## CORNELL RESPONSES TO QUESTIONS AND COMMENTS ON CORNELL ULURP APPLICATIONS

(Questions by LARRY PARNES, 11/18/12)

# Height and Setback Controls

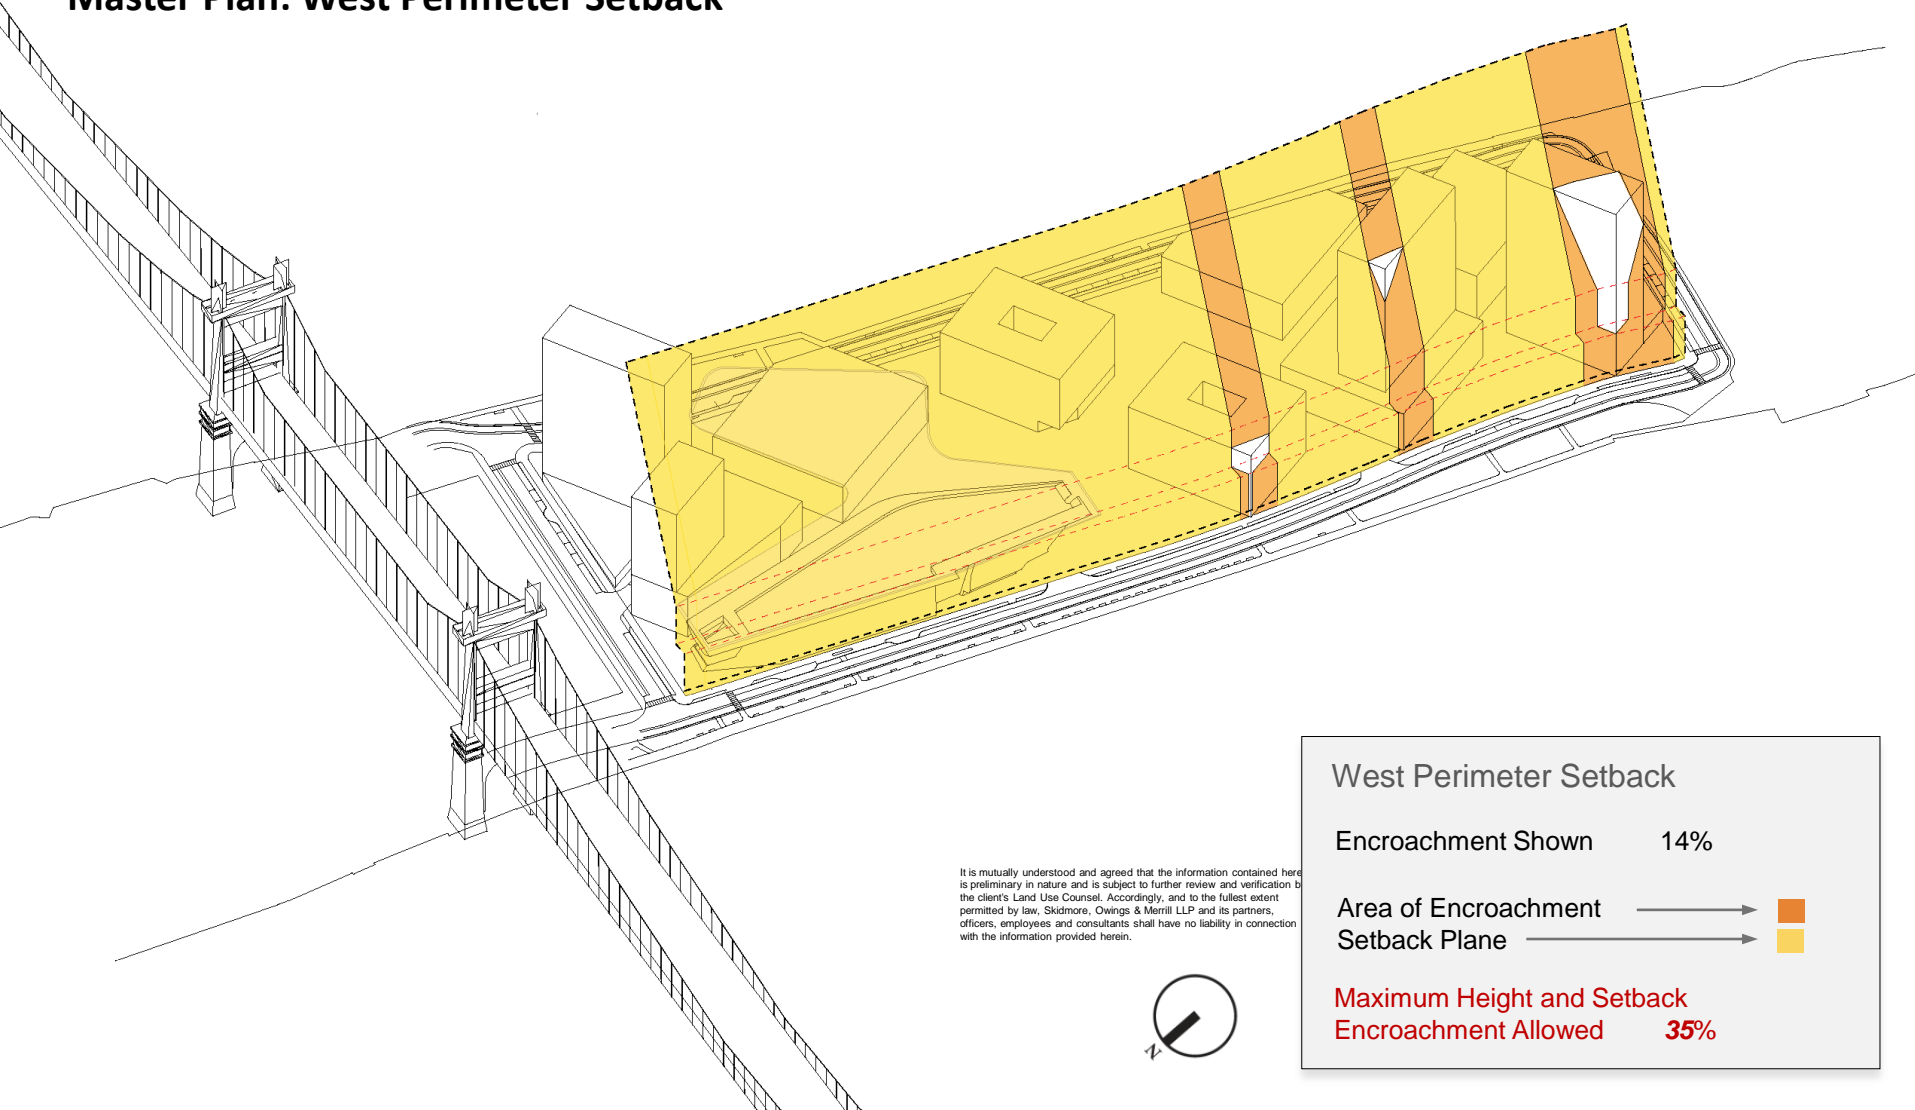
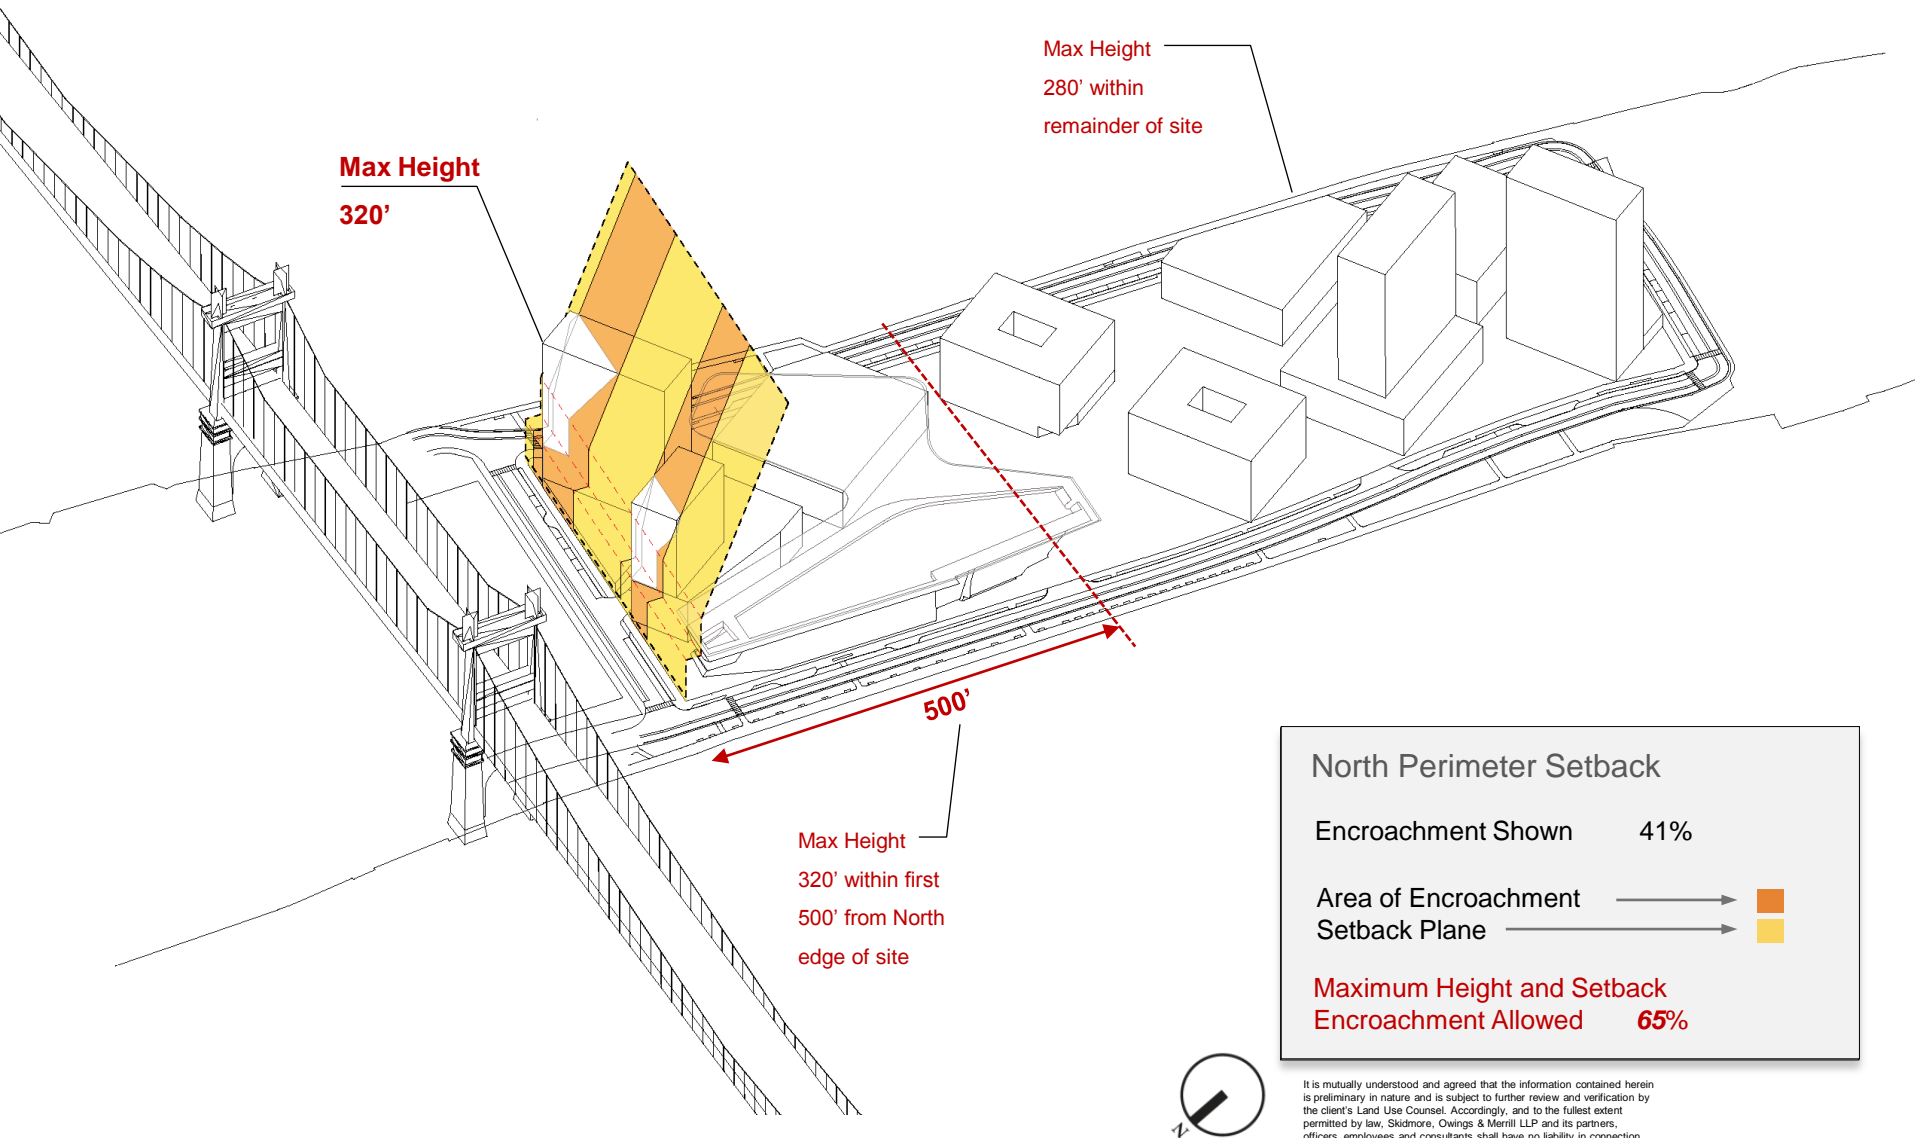
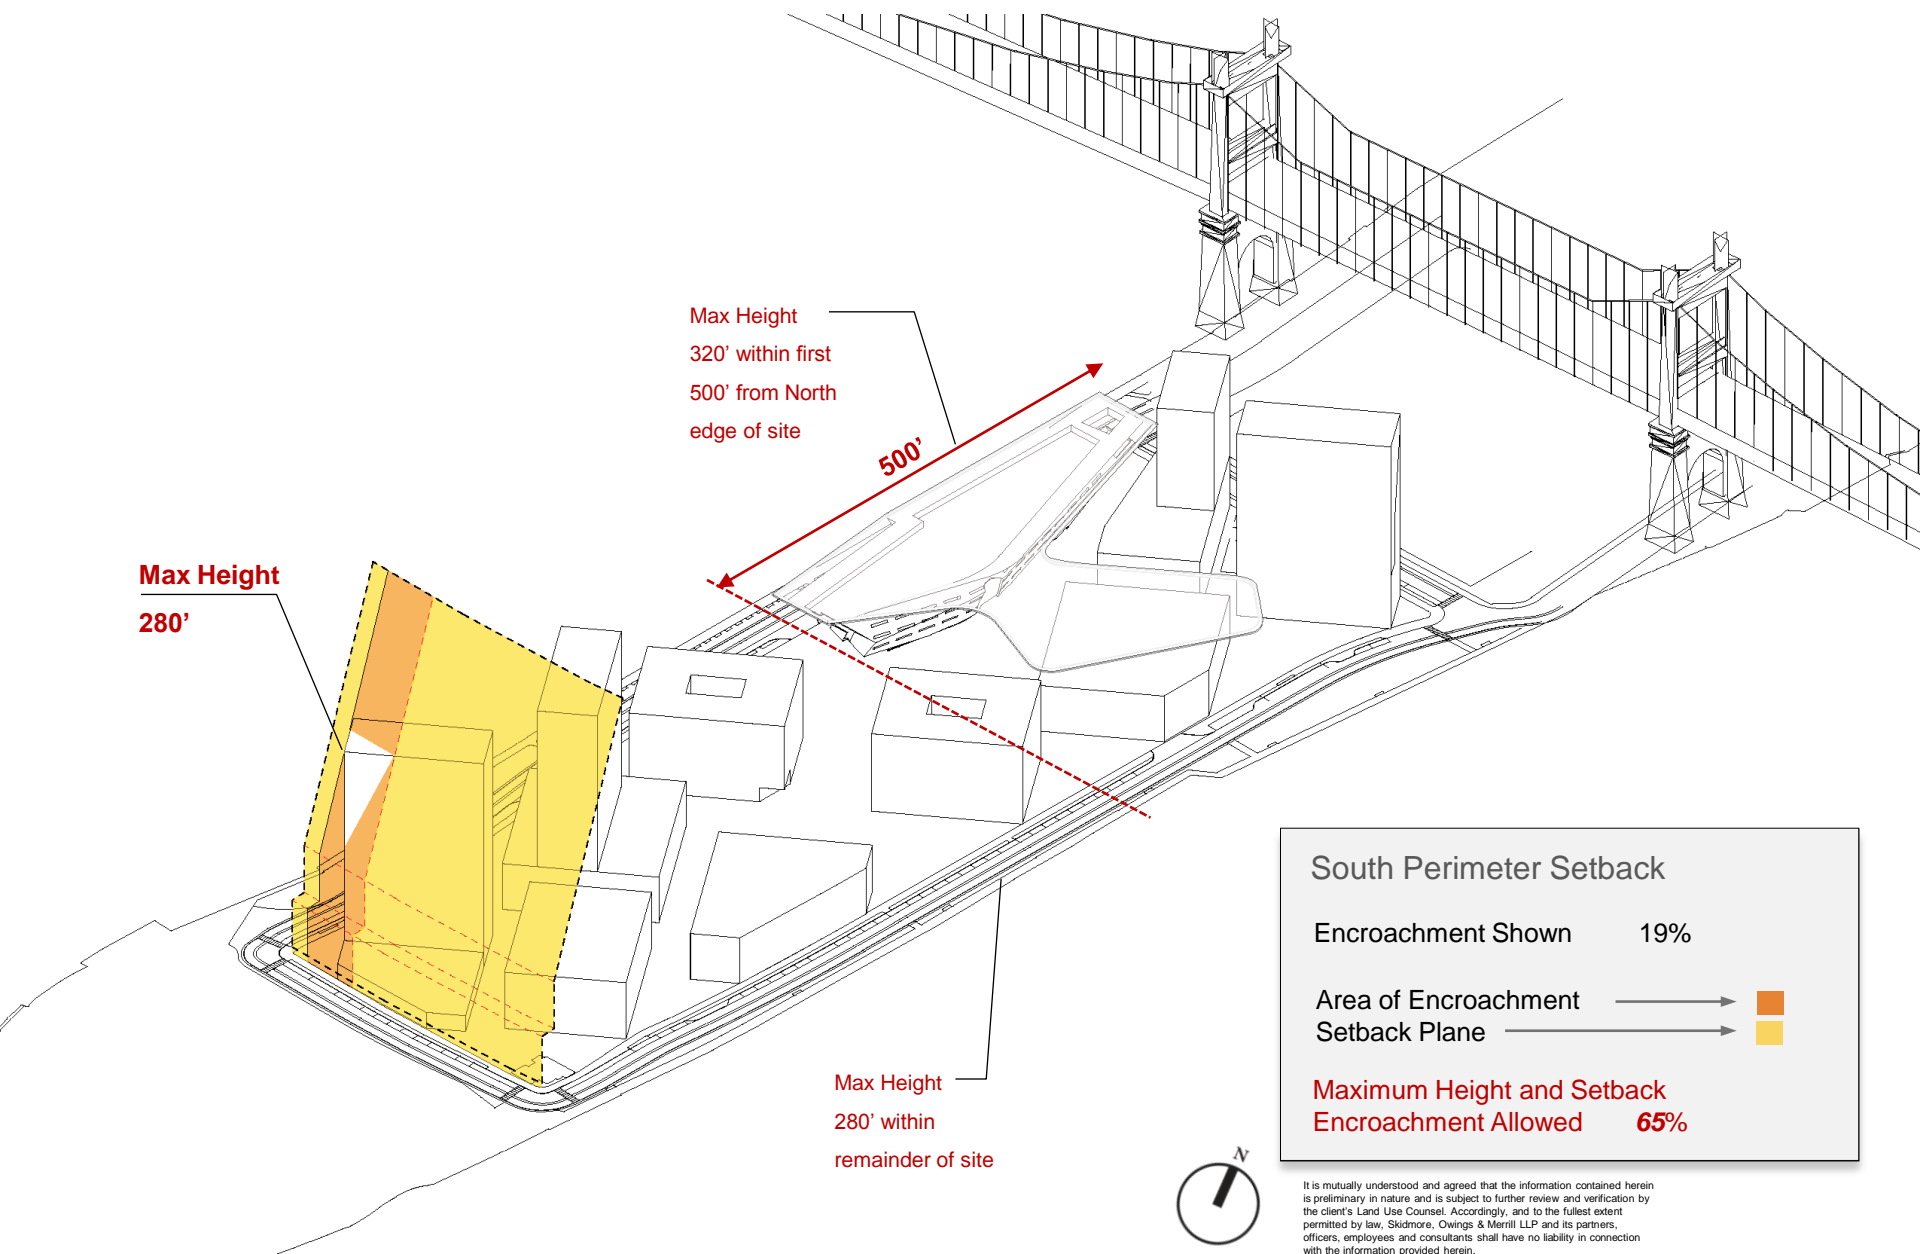
- The provisions of Section 133-231 are very technical and illustrations would be helpful to understand the provisions and intent. An illustration would also be useful to understand the areas affected by Section 133-232.

**RESPONSE:** The architect has developed a series of diagrams to help explain the zoning controls, which are attached.

# Distance Between Buildings

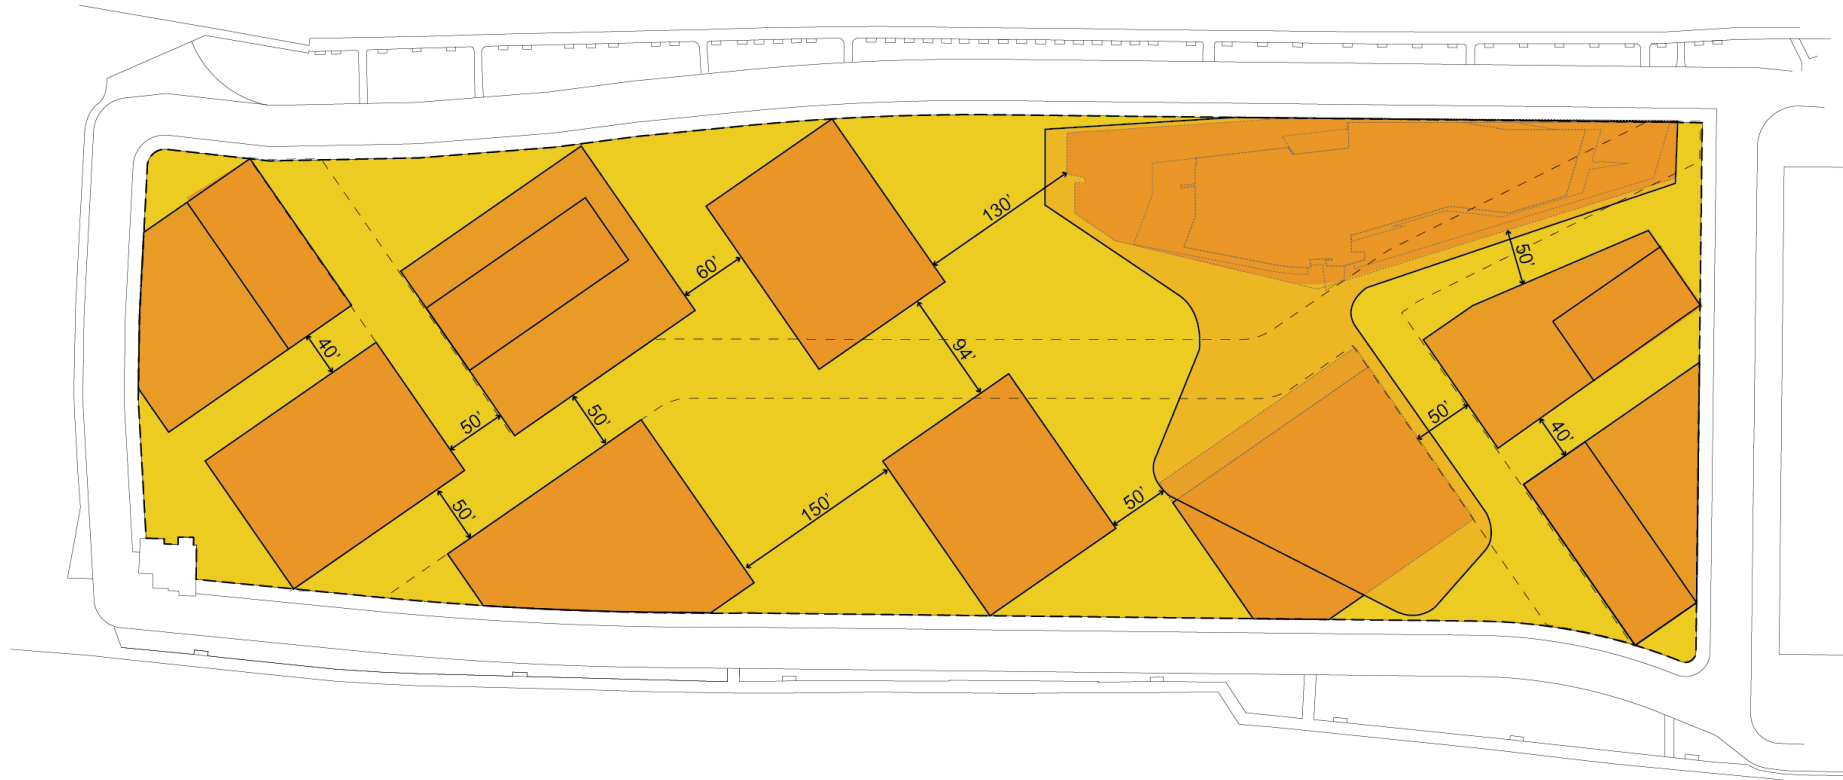
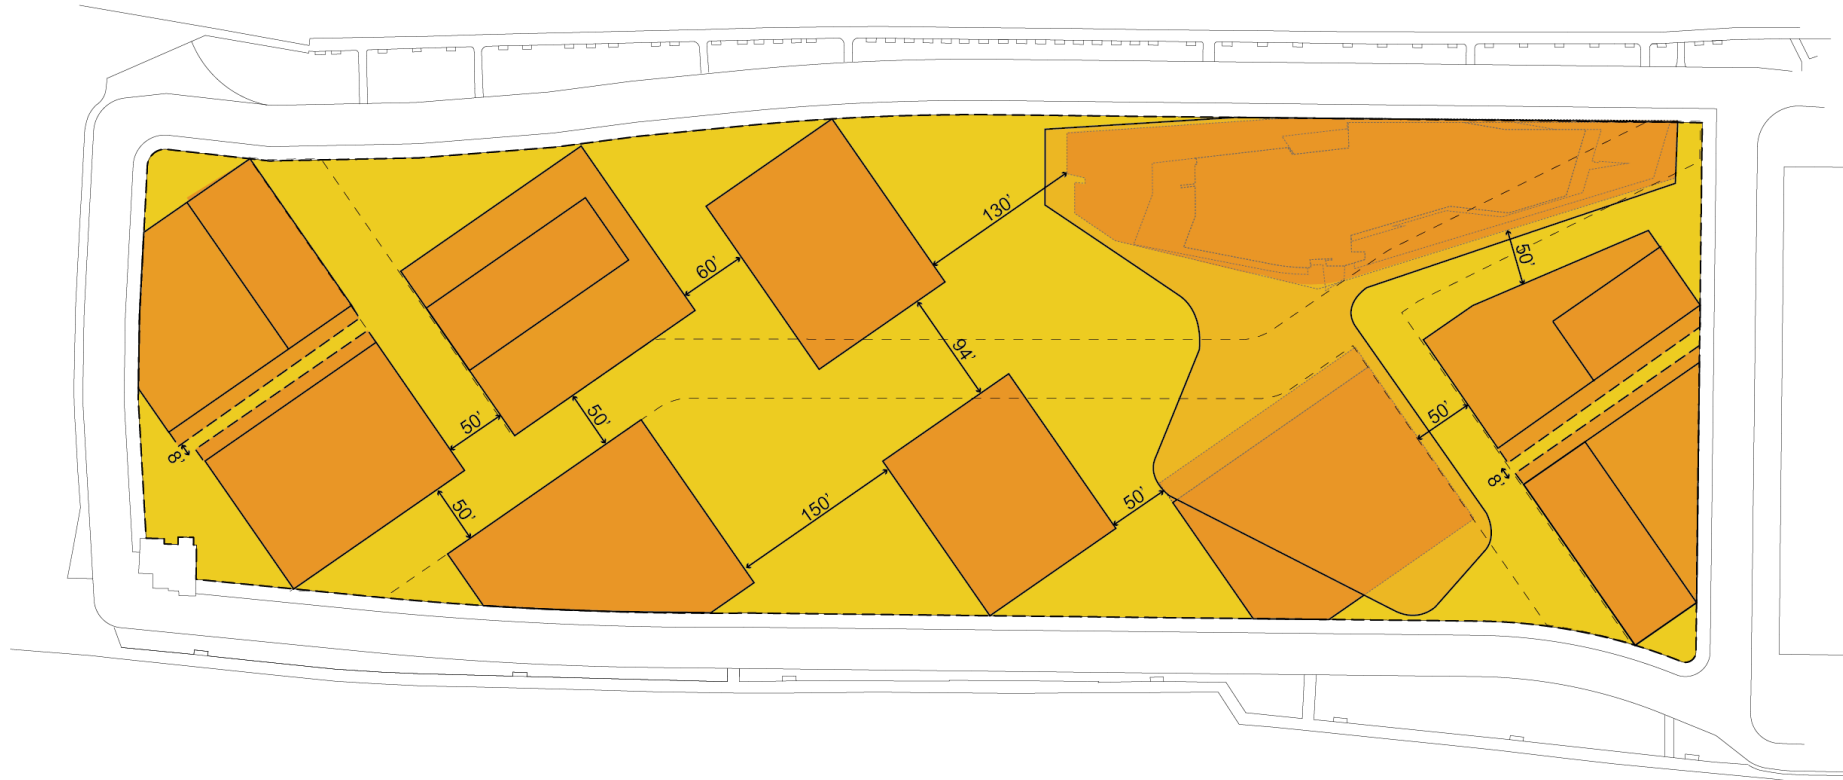
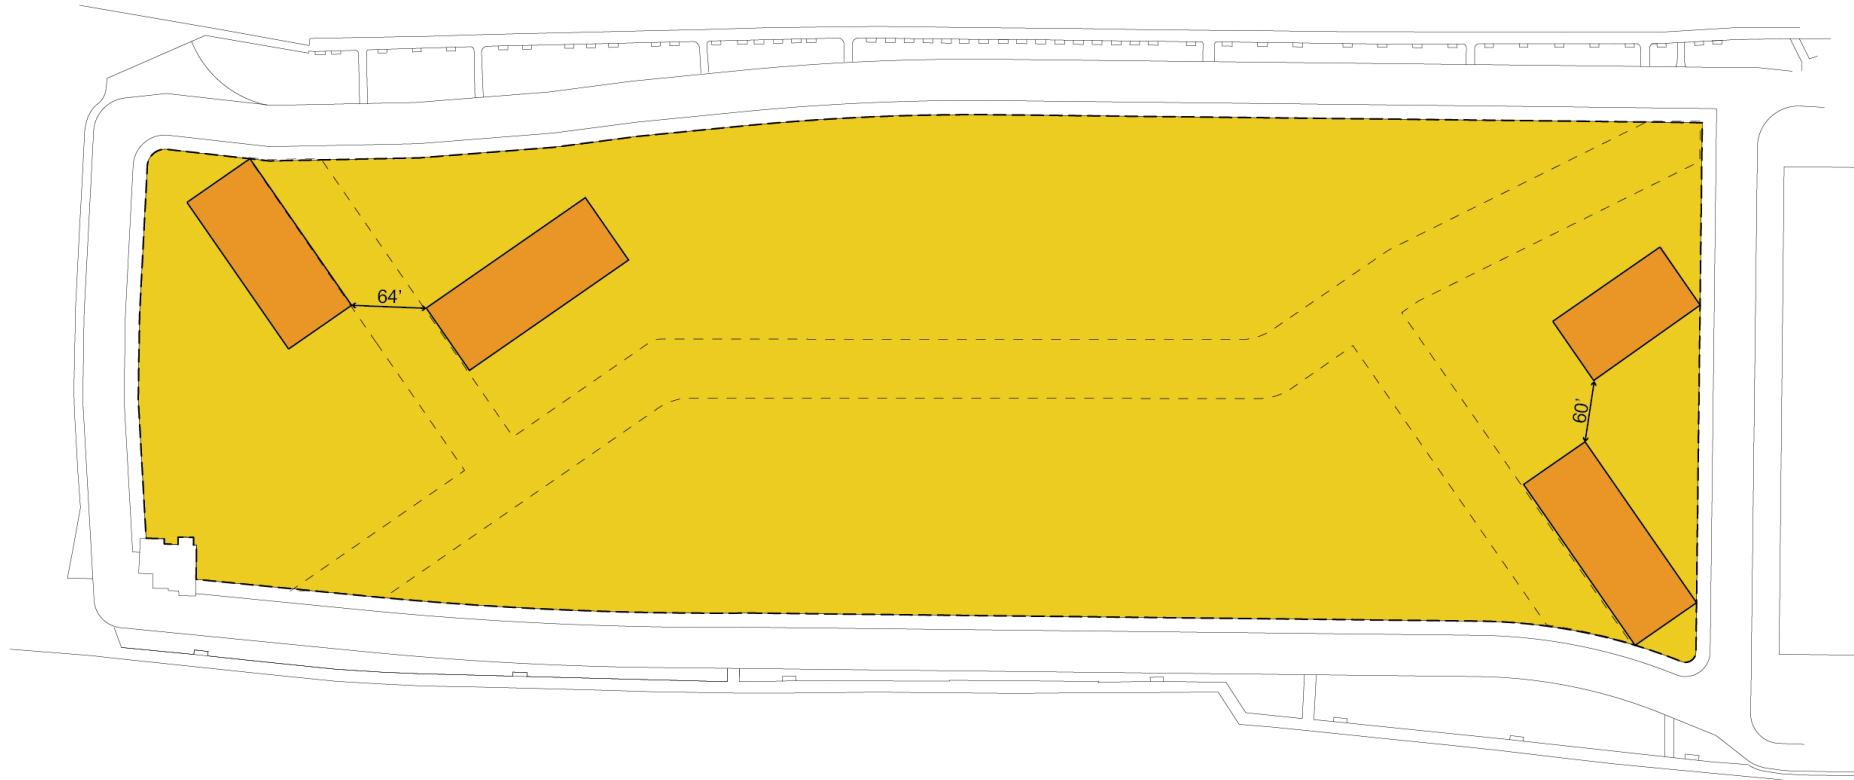
- The zoning comparison chart included in the application does not include information relating to distance between buildings. This information is necessary to understand the modifications of Section 133-24. An illustration would also be useful.

**RESPONSE:** Under C4-5 zoning, there are no distance requirements between commercial and community facility uses, and residential uses are required to be between 40 and 60 feet away from another building. The proposed zoning would require at least eight feet of separation between buildings below a height of 180 feet, and at least 60 feet of separation above a height

of 180 feet. This allows for the buildings to be somewhat concentrated on the site, which in turn allows for larger areas of publicly accessible open spaces. A diagram showing this requirement is attached.
